# Access Compliance Report

## Public Rights-of-Way

Intersection ID: 8795	Main Street: BANCROFT_ST	Cross Street: DOGWOOD_AV	Location: SE
ADA ID: 5C7137F96B78	Ramp Type: Perp	Initial Pass/Fail: Pass	Overall Compliance: No
Severity Score: 12.5			
Codes/Mitigation Info/Possible Solution		Field Measurements/Component Compliance

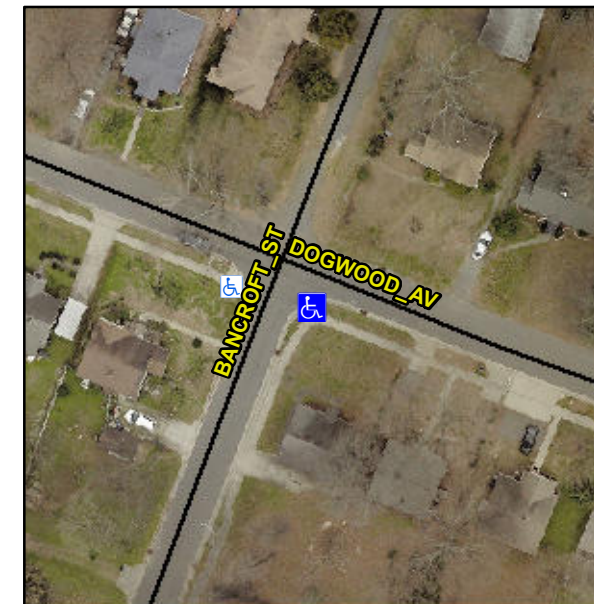
**Not Found, R305.2, R302.7.2,  
R304.5.4, R304.5.3**

Compliance	Description	Data	Compliance	Description	Data
N/A	Ramp Length (in)	61.0	Yes	Ramp Slope (%)	8.0
Yes	Ramp Width (in)	49.0	Yes	Ramp XSlope (%)	1.7
N/A	Flare Type LT	Sloped	N/A	Flare Type RT	N/A
N/A	Flare Slope LT (%)	10.5	N/A	Flare Slope RT (%)	3.5
N/A	Flare Traversable LT?	No	N/A	Flare Traversable RT?	No
Yes	Landing Length (in)	59.5	Yes	DWS Provided?	Yes
Yes	Landing Width (in)	48.0	Yes	DWS Contrast?	Yes
Yes	Landing Slope (%)	1.4	Yes	DWS Length (in)	24.0
Yes	Landing X Slope (%)	1.7	Yes	DWS Full Width?	Yes
N/A	Landing Curb? (Y/N)	No	No	DWS Offset (in)	5.0
N/A	Shared Landing?	No			
Yes	Gutter Ponding?	No	No	Gutter Slope (%)	6.0
No	Gutter Lip Ht (in)	0.5	No	Gutter X Slope (%)	2.1
N/A	Painted X Walk1?	No	N/A	Painted X Walk2?	N/A
	X Walk 1 Direction	To NW		X Walk 2 Direction	N/A
N/A	X Walk 1 Width (in)	N/A	N/A	X Walk 2 Width (in)	N/A
	X Walk 1 Slope (%)	2.9		X Walk 2 Slope (%)	N/A
	X Walk 1 X Slope (%)	0.6		X Walk 2 X Slope (%)	N/A

N/A	Ramp inside XWalk1?	N/A	N/A	Ramp inside XWalk2?	N/A
	Road Slope (%)	N/A	N/A	Clear Space?	Yes
	Road X Slope (%)	N/A	N/A	Clear Space to XWalk (in)	N/A
Yes	Any Obstructions?	No	Yes	Storm Grate/Utility Hazard?	No
	Obstruction Type			Storm Grate/Utility Type	
		N/A			N/A
			Yes	Surface Condition? (G/P)	Good

**Remove & Replace Entire Ramp.  
Remove & Replace Gutter.**
